WARRANTY BULLETIN

Wb04-02

SUBJECT: REPLACEMENT OF NEUTRAL SAFETY SWITCH

ON ZF ASTRONIC TRANSMISSION

FIGURE 1: IDENTIFICATION PLATE

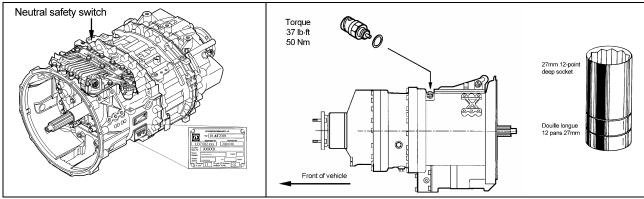
- 1. Raise the vehicle.
- 2. Check the serial number written on the R.H. side identification plate (figure 1). If the serial number is below 250872, it is necessary to replace the neutral safety switch.
